Re: Waterloo Wind farm stage 2 Application to Vary Generation License and add 6 turbines (V117)

Relationship to the Waterloo Wind farm stage 2 Project: near neighbour

Distance from Residence to Nearest Turbine: 1599 metres

Figure 5-1 Planning

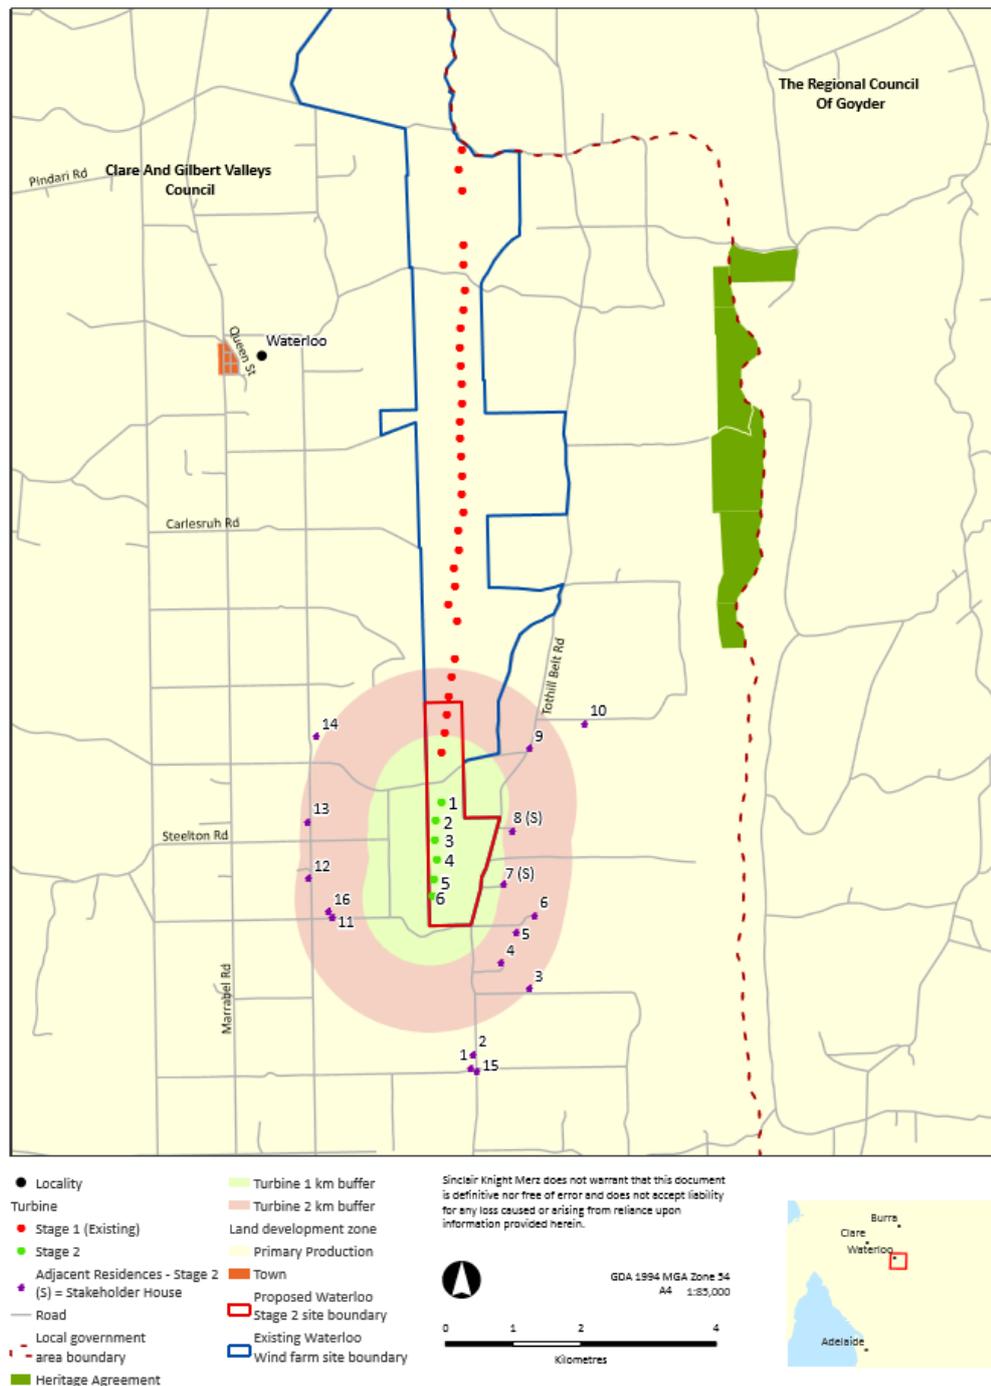
See map below from 2012 Development Application Figure 5-1 Planning. This gives a more representative view of the wind farm site and surrounds and shows how unacceptably close the turbines are sited to local houses.

10. The setbacks to houses for the Waterloo stage 2 development are insufficient, inconsistent with and significantly less than the 2 km setbacks for the neighbouring Stony Gap wind farm (proposed by the same developer and operator of the Waterloo wind farm stage 1 – Energy Australia.) Residents at Waterloo should be allowed the same 2 km setbacks as Stony Gap residents.
11. Turbines are sited too close to neighbours’ boundaries. Turbine blades will over-sail neighbours land. This is an unacceptable hazard according to SAFEWORK SA submission to the 2011 Ministerial Wind farms DPA because of the risk of turbine failure. Neighbours should not have to be subjected to whirring blades immediately overhead whilst utilising their property.

Waterloo Wind Farm Stage 2 Turbines - Spacing does not meet Vestas Specifications.

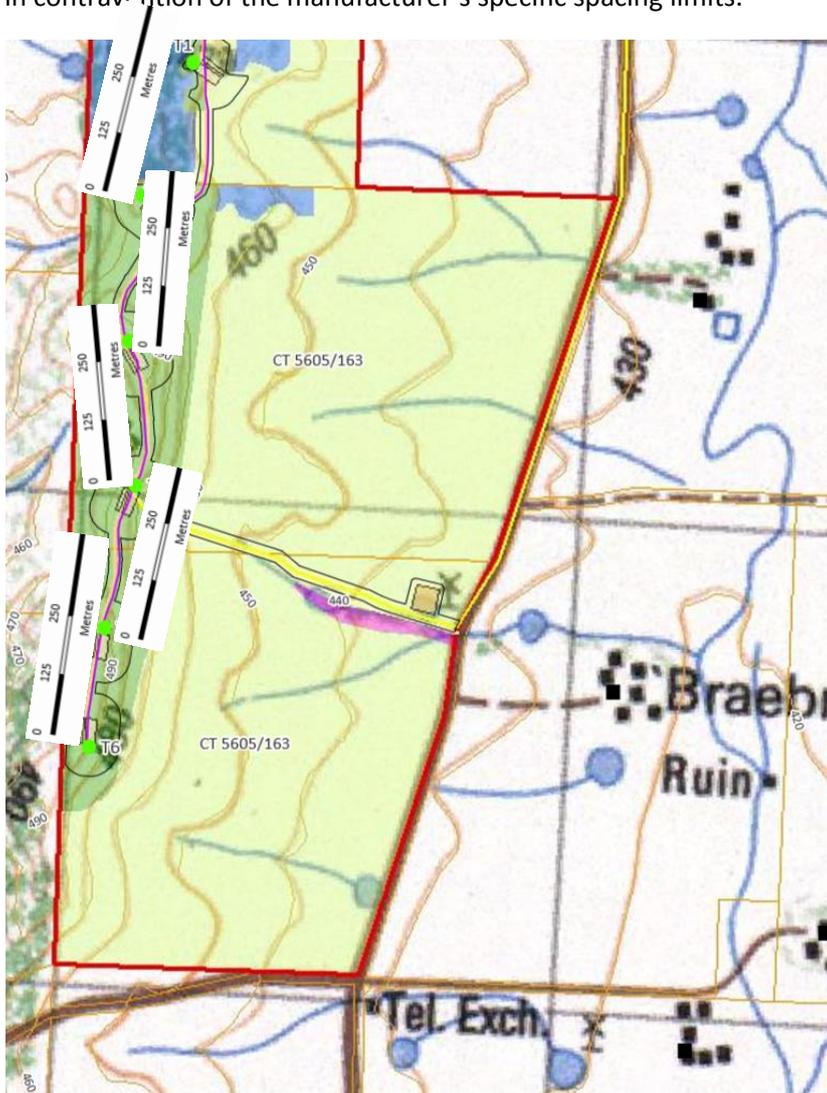
Vestas V117 are named on the Waterloo wind farm ESCOSA license variation [1] as the turbine to be used for Waterloo wind farm Stage 2. These have a rotor diameter of 117 metres. [2]

3 Rotor Diameters for the V117 = $117 \times 3 = 351$ metres. Examination of the map PI30386 Waterloo Wind Farm Stage 2 [3] shows that the spacing of all 6 turbines appears to be below 351 metres (3 rotor diameters and therefore all are in contravention of the manufacturer’s specific spacing limits.
